STAFF REPORT
COMMUNITY DEVELOPMENT DEPARTMENT

HEARING DATE: 5/18/2022
TO: Mayor & City Council
FROM: Sonya Allen, Associate Planner
208-884-5533
SUBJECT: FP-2022-0013
Aviator Springs No. 1
LOCATION: 3235 N. McDermott Rd., in the SE 1/4 of
Section 32, T.4N., R.1W.

Final plat consisting of 95 buildable lots (93 single-family residential & 2 commercial) and 13 common lots on 25.35 acres of land in the R-8 and L-O zoning districts for the first phase of Aviator Springs Subdivision.

L1.00

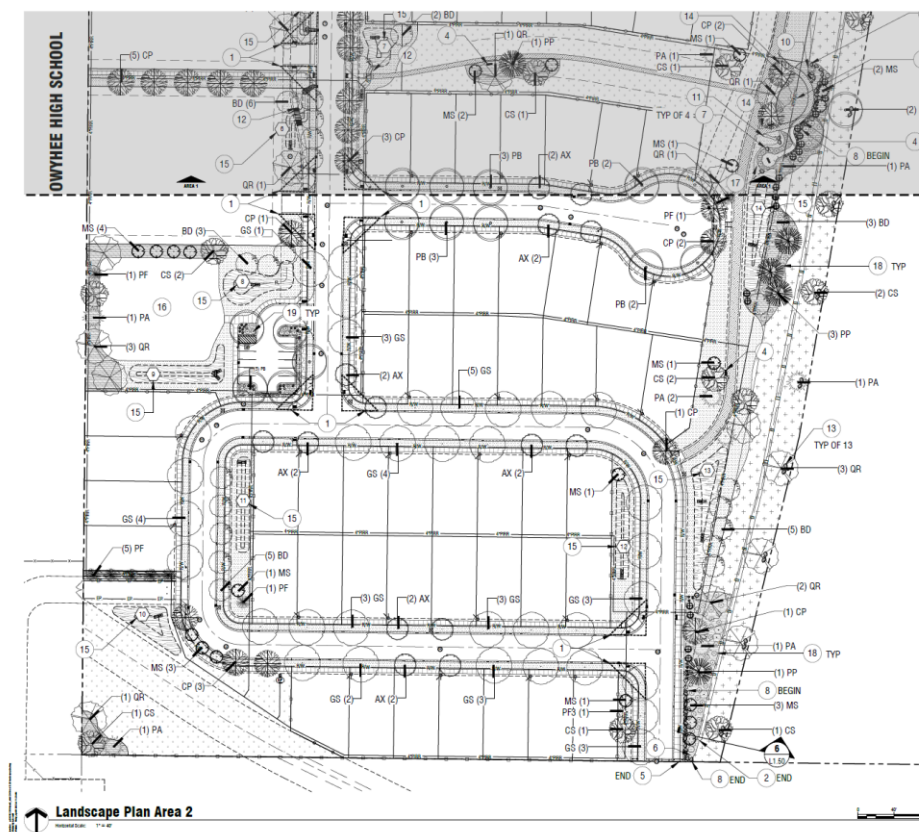
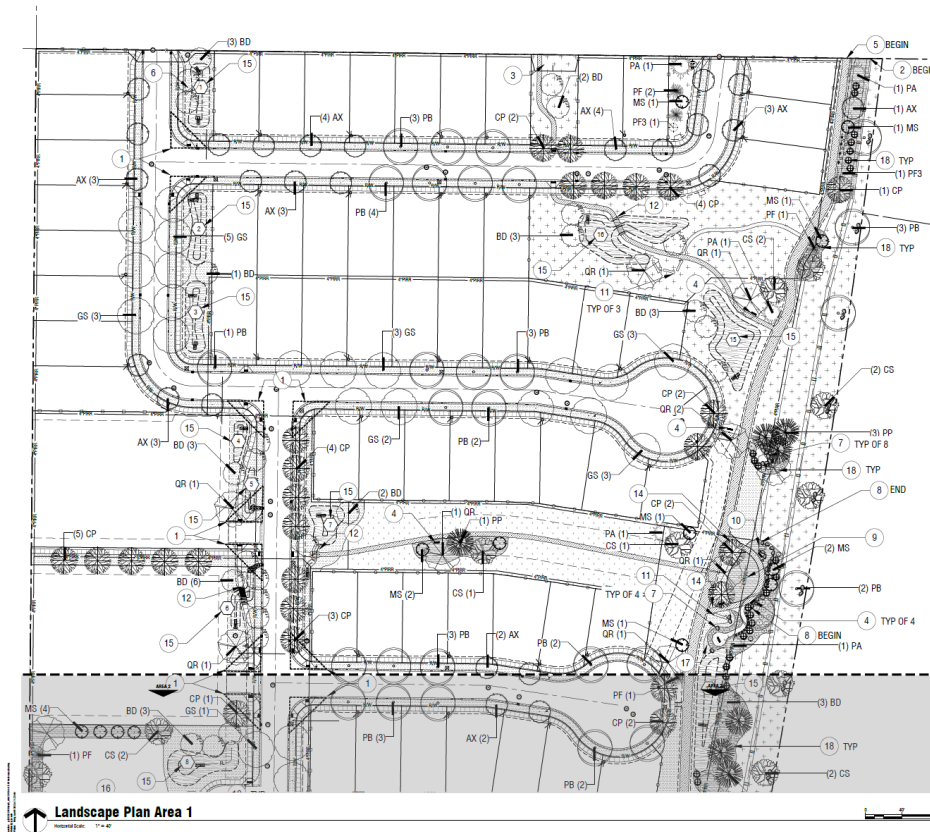
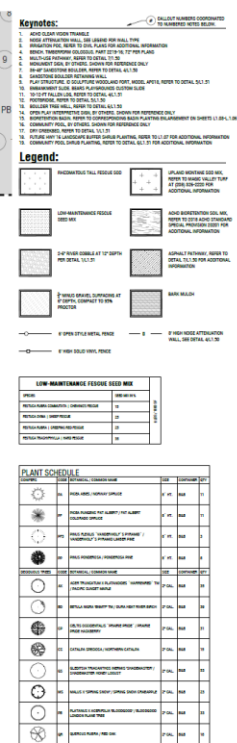
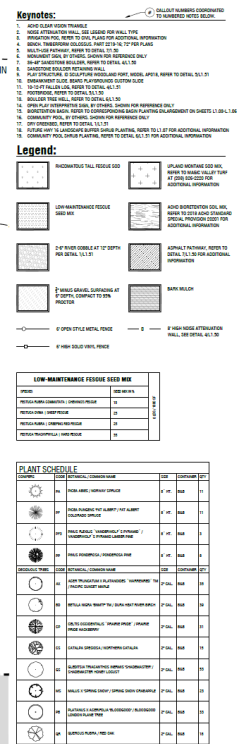
5. The landscape plan prepared by The Land Group, Inc., dated 4/7/2022, included in Section V.C, shall be revised as follows:
 - a. In Project Calculations table, include the required number of residential subdivision trees as set forth in UDC 11-3B-7C (1 per 35', may deduct 26' for each driveway); include the required number of trees along micro-paths as set forth in UDC 11-3B-12C.2 (one tree per 100').

- b. Include the tree classification (i.e. I, II or III) in the Plant Schedule. All parkway trees should be Class II in accord with UDC 11-3A-17E.
 - c. Include a detail of the proposed wall along the east boundary along future SH-16 that demonstrates compliance with the standards in UDC [11-3H-4D.3](#).

- d. All stormwater swales incorporated into required landscape areas shall comply with the standards listed in UDC [11-3B-11C](#).
 - e. The pathway on Lot 10, Block 1 shall be redesigned/relocated so that landscape strips are provided on each side of the pathway in accord with the standards listed in UDC [11-3B-12C.1](#).

- f. Depict landscaping along all pathways in accord with the standards listed in UDC [11-3B-12C.2](#); include a mix of trees, shrubs, lawn and/or other vegetative groundcover.

A copy of the revised landscape plan shall be submitted with the final plat for City Engineer signature.
